SUBMISSION ON THE DRAFT WESTERN SYDNEY AEROTROPOLIS PRECINCT PLANS

This submission has been prepared by Urbis Pty Ltd (**Urbis**) on behalf of Suttons Motor Group (**Suttons**) in response to the release of the draft Aerotropolis Precinct Plan (**Precinct Plan**). As a landowner within the Aerotropolis, Suttons welcomes the opportunity to comment on the draft Precinct Plan and seeks a partnership on the delivery of the Badgerys Creek precinct. It is critical to ensure the draft Precinct Plan provides the right balance to enable flexibility in planning controls to deliver development on-the-ground tomorrow but not preclude each precinct's ability to contribute to the Western Parkland City vision.

Figure 2 Proposed Amalgamation Plan

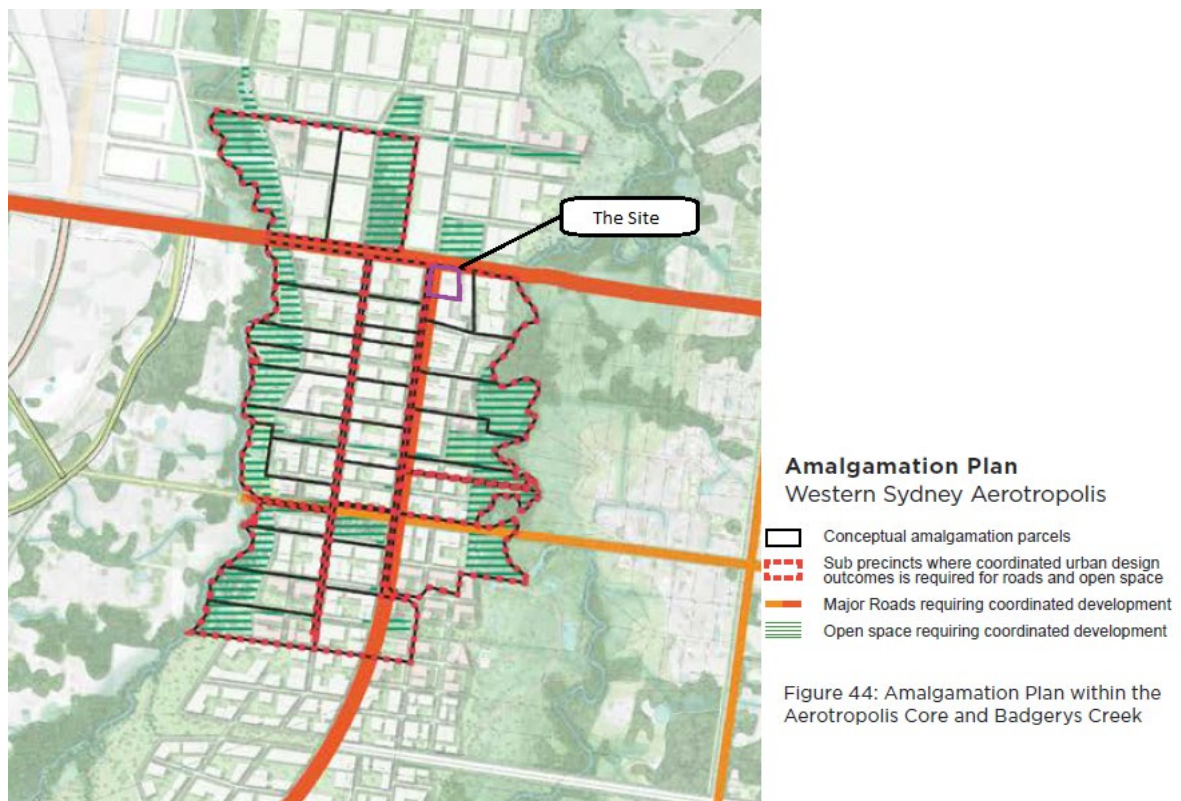
The draft Precinct Plan also includes a requirement for the amalgamation of land to a minimum of 5ha in areas shown within the amalgamation plan. Whilst the amalgamation plan itself does not appear to identify 10 Martin Road as an allotment that would require amalgamation with adjacent sites, the site area is less than 5ha and under requirements LU6 would require amalgamation with the adjacent sites.

We note that allotments directly adjacent to the site are also identified for amalgamation. Both these sites are currently zoned SP2 – Airport. Whilst the ultimate use of these adjacent parcels is not known, they are zoned BD1 – Business Development under the Western Sydney Airport Plan and as such could accommodate a wide range of future land uses associated with Western Sydney Airport which may or may not align with Suttons future development intentions.

Under the minimum site amalgamation requirement, the Suttons site would be required to be amalgamated with adjacent land that is currently zoned SP2 and owned by the Commonwealth. **This is clearly an unacceptable outcome and one which Suttons strongly objects to as it would in effect sterilise the landholding until these sites are ready to develop.** Further we note that neither the Aerotropolis SEPP nor the draft Precinct Plan have any statutory authority over these Commonwealth allotments.

The inclusion of these Commonwealth sites in an amalgamation plan illustrates the complete lack of knowledge of existing site ownership patterns and zoning. Given that the controls within the precinct plan (and the associated Figures) are 'conceptual' and have been provided to 'encourage' the amalgamation of smaller allotments. It is therefore unacceptable that such a definitive amalgamation plan be included in a statutory document.

The amalgamation plan is also unclear as to the boundaries of each sub-precinct and future road widths for the 'Eastern Ring Road' which appears to encroach into private properties (including the Suttons landholding) without providing any specific details around future acquisition requirements within either the Precinct Plan nor the Aerotropolis SEPP.

Given the adjacent SP2 zoned land adjacent to the site, it is critical that the draft Precinct Plan provides flexibility around lot amalgamation and removes the specific requirement for a minimum 5ha amalgamation requirement to ensure that the Suttons landholding is not sterilised from future development.

5. Suttons strongly objects to the 5ha minimum site amalgamation requirement within the draft Precinct Plan. The Suttons site would be required to be amalgamated with adjacent land that is currently zoned SP2 and owned by the Commonwealth. This is clearly an unacceptable outcome. The future development of the site must not be sterilised as a result of this minimum amalgamation requirement.

6. The 5ha minimum site amalgamation requirement must be removed from the draft Precinct Plan. If it is intended that this plan be 'conceptual' then the amalgamation plan must be removed from the draft Precinct Plan placed within a non-statutory document such as the Stage 2 DCP.

7. Allotments zoned SP2 Airport must be removed from the amalgamation plan as the Precinct Plan has no statutory authority over these adjacent land parcels.

8. The WSPP must clarify the amount of information required to demonstrate how the adjacent sites to be amalgamated would integrate with surrounding sites. Is it merely a consultation requirement or must future development to and from adjacent sites be reflected in the plans?

Figure 3 Comparison of Zoning and Precinct Plan

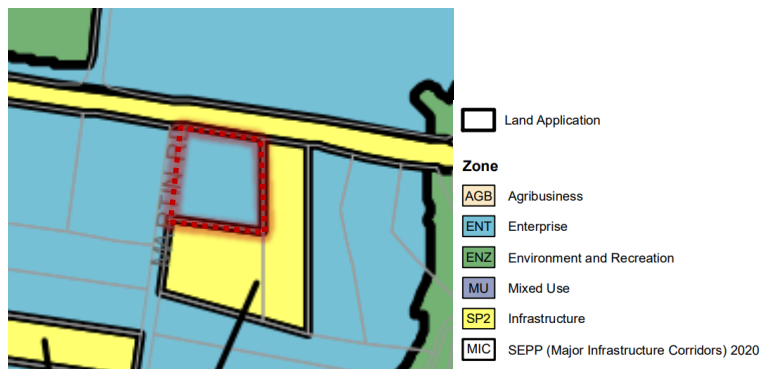
The adoption of urban development zones within the Aerotropolis SEPP sought to minimise spot rezoning and provide the market flexibility to respond to demand. The detail contained in the draft Precinct Plan (refer Figure 2, Picture 3) diminishes the effectiveness of the urban development zones as it identifies building footprints and specific land uses.

This detail should be removed from the precinct plan. It should be up to the market to determine the type of land uses and their locations within the context of the draft Precinct Plan. By detailing land use types and building footprints, it prevents flexibility and market response to investment in the Aerotropolis.

9. The draft Precinct Plan must remove detail on land use types and building footprints, as it conflicts with the intent of the urban development zone. Land uses should be dictated by the market and evidence-based technical investigations at the DA stage.

Figure 4 Draft Precinct Plan Road Hierarchy

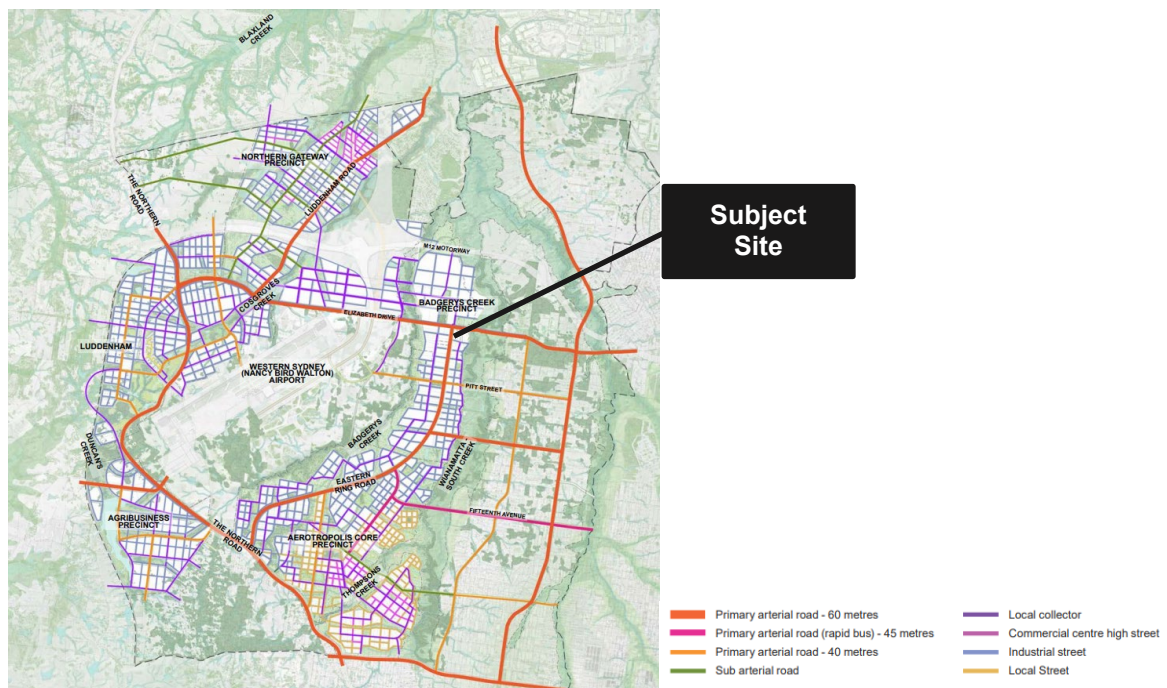
The Precinct Plan identifies that Martin Road will form part of the future Eastern Ring Road. The Eastern Ring Road will serve as the primary north-south arterial road connection between Elizabeth Drive to the north to The Northern Road to the south (refer to **Figure 4**).

The Eastern Ring Road has been identified as a key component of the future road, freight, bus and active transport networks for the Aerotropolis. Given the strategic importance of this road, it is expected that the Martin Road segment will see a significant increase in number of vehicles, pedestrians and cyclists.

13. There is a lack of coordination between the WSPP and TfNSW on the Eastern Ring Road and Elizabeth Drive Upgrade access arrangements which will prevent viable developments from occurring. The WSPP and Transport for NSW must provide for access of Martin Road /Eastern Ring Road to the site to ensure access to Elizabeth Drive towards the east. This will ensure that any development of the site is viable and not prevented by the uncertainty resulting from the Elizabeth Drive upgrade and Eastern Ring Road.

14. The WSPP and TfNSW must urgently engage with the affected land holders (including Suttons) on the design and planning phase for the Eastern Ring Road to resolve any discrepancy from the strategic design and detail design of Eastern Ring Road. Any changes which would require an immediate update of the Aerotropolis SEPP and draft Precinct Plan must be undertaken to ensure appropriate acquisition, corridor protection and delivery can occur in an efficient and timely manner. Certainty must be provided to all affected landowners to minimise the risk of future land sterilisation.

Figure 5 Interim access arrangements

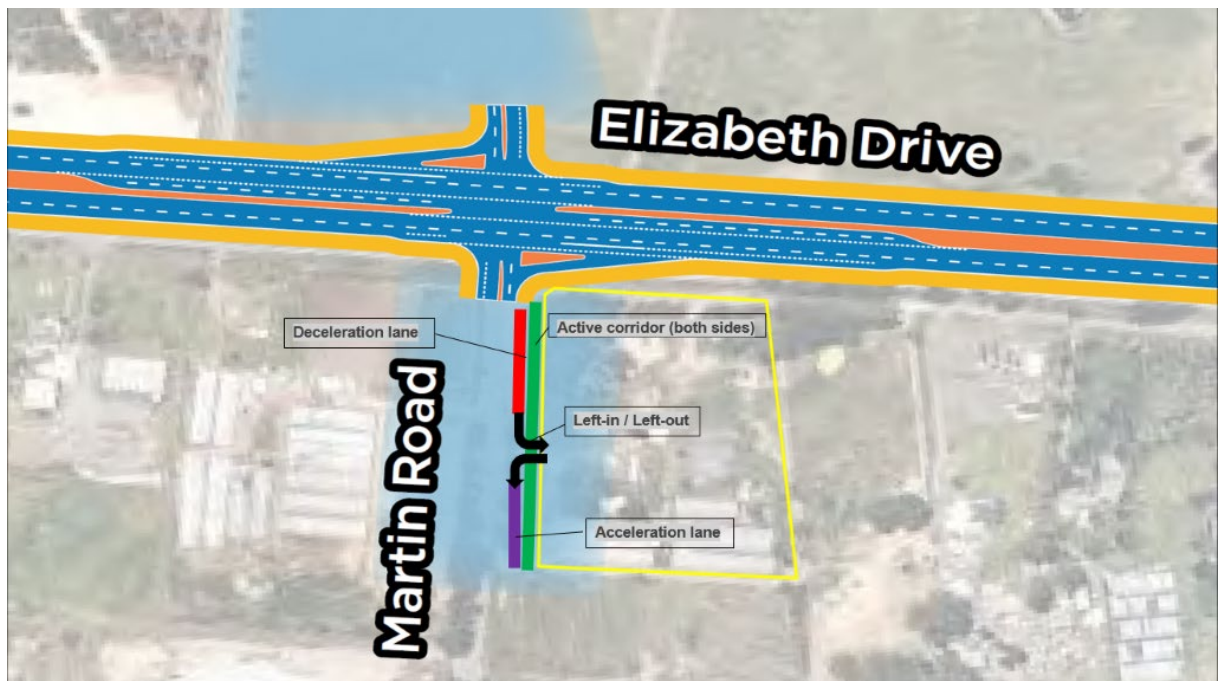
Given the site's strategic location between two major arterial roads, access to and from the site is a critical consideration. Both the draft Precinct Plan and any future design of Elizabeth Drive consider access the future access arrangements to and from the site. With access to Elizabeth Drive potentially severely constrained, the site needs access to Martin Road be able to turn right back towards Elizabeth Drive. The timing and delivery of the development must not be delayed or prevented and as such, the WSPP must consider interim access arrangements as proposed in **Figure 5** below.
